Access Compliance Report

Public Rights-of-Way

(Curb Ramps)

Intersection ID: 42743	Main Street: CRUTCHFIELD_PL	Cross Street: MACANTHRA_DR	Location:	NW
ADA ID: 776F7560B5A3	Ramp Type: PerpDiag	Initial Pass/Fail: Fail	Overall Compliance: No	Severity Score: 35
Codes/Mitigation Info/Possible Solution		Field Measurements/Component Compliance

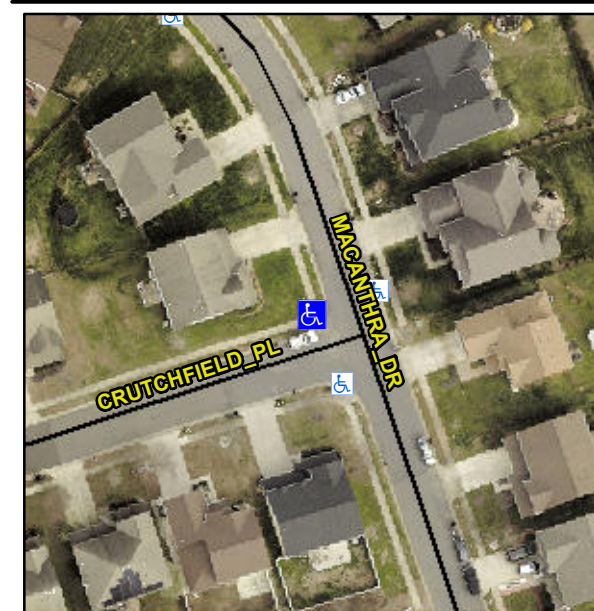
Not Found, R304.5.1, R304.2.2, R304.5.3

Compliance	Description	Data	Compliance	Description	Data
N/A	Ramp Length (in)	51.0	No	Ramp Slope (%)	16.1
No	Ramp Width (in)	38.0	No	Ramp XSlope (%)	2.9
N/A	Flare Type LT	N/A	N/A	Flare Type RT	N/A
N/A	Flare Slope LT (%)	N/A	N/A	Flare Slope RT (%)	N/A
N/A	Flare Traversable LT?	N/A	N/A	Flare Traversable RT?	N/A
N/A	Landing Length (in)	N/A	N/A	DWS Provided?	N/A
N/A	Landing Width (in)	N/A	N/A	DWS Contrast?	N/A
N/A	Landing Slope (%)	N/A	N/A	DWS Length (in)	N/A
N/A	Landing X Slope (%)	N/A	N/A	DWS Full Width?	N/A
N/A	Landing Curb? (Y/N)	N/A	N/A	DWS Offset (in)	N/A
N/A	Shared Landing?	N/A			
N/A	Gutter Ponding?	N/A	N/A	Gutter Slope (%)	N/A
N/A	Gutter Lip Ht (in)	N/A	N/A	Gutter X Slope (%)	N/A
N/A	Painted X Walk1?	No	N/A	Painted X Walk2?	No
	X Walk 1 Direction	To S		X Walk 2 Direction	To E
N/A	X Walk 1 Width (in)	N/A	N/A	X Walk 2 Width (in)	N/A
	X Walk 1 Slope (%)	1.5		X Walk 2 Slope (%)	0.7
	X Walk 1 X Slope (%)	0.5		X Walk 2 X Slope (%)	2.3

Remove & Replace Curb Ramp With Two New Directional Ramps or Equivalent.
